**DISCUSSION OF REVISION
TO THE
RADIOLOGICAL EMERGENCY PLAN ANNEX
FOR
BRAIDWOOD STATION
EP-AA-1001**

DEVELOPMENT OF EMERGENCY ACTION LEVELS FOR NON-PASSIVE REACTORS

ATTACHMENT 2
**DISCUSSION OF REVISION TO THE RADIOLOGICAL
EMERGENCY PLAN ANNEX FOR
BRAIDWOOD STATION**

RECOGNITION CATEGORY FISSION PRODUCT BARRIER DEGRADATION Figure 9-F-4: PWR Containment Integrity or Bypass Examples

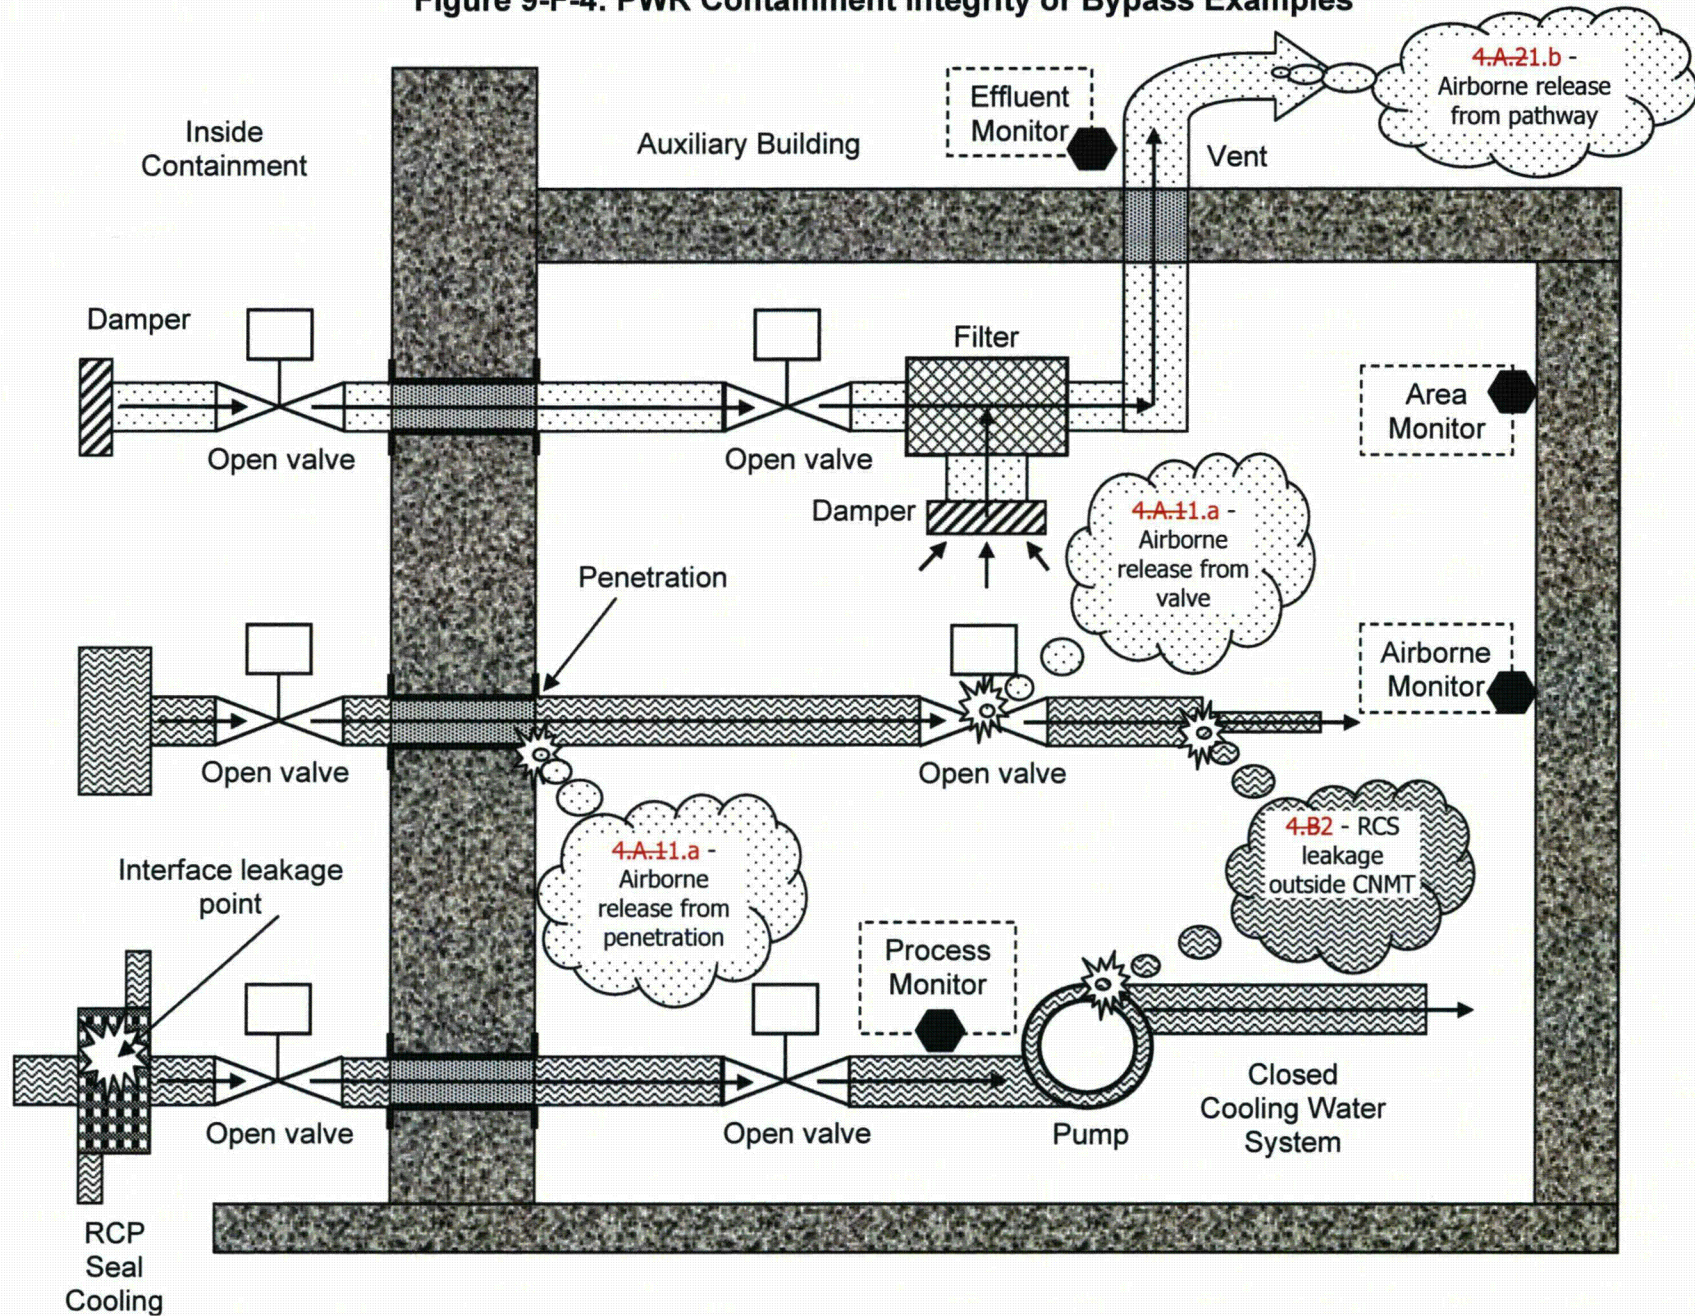
Refer to the middle piping run of Figure 9-F-4. Two simplified examples are provided. One is leakage from a penetration and the other is leakage from an in-service system valve. Depending upon radiation monitor locations and sensitivities, the leakage could be detected by any of the four monitors depicted in the figure.

Refer to the top piping run of Figure 9-F-4. In this simplified example, the inboard and outboard isolation valves remained open after a containment isolation was required (i.e., containment isolation was not successful). There is now an UNISOLABLE pathway from the containment to the environment.

Refer to the bottom piping run of Figure 9-F-4. In this simplified example, leakage in an RCP seal cooler is allowing radioactive material to enter the Auxiliary Building. The radioactivity would be detected by the Process Monitor. If there is no leakage from the closed water cooling system to the Auxiliary Building, then no threshold has been met. If the pump or system piping developed a leak that allowed steam/water to enter the Auxiliary Building, then **loss** threshold **24.B** would be met. Depending upon radiation monitor locations and sensitivities, this leakage could be detected by any of the four monitors depicted in the figure and cause threshold **1.a4.A.1** to be met as well.

Refer to the middle piping run of Figure 9-F-4. In this simplified example, a leak has occurred at a reducer on a pipe carrying reactor coolant in the Auxiliary Building.

Depending upon radiation monitor locations and sensitivities, the leakage could be detected by any of the four monitors depicted in the figure and cause **loss** threshold **1.a4.A.1** to be met as well.
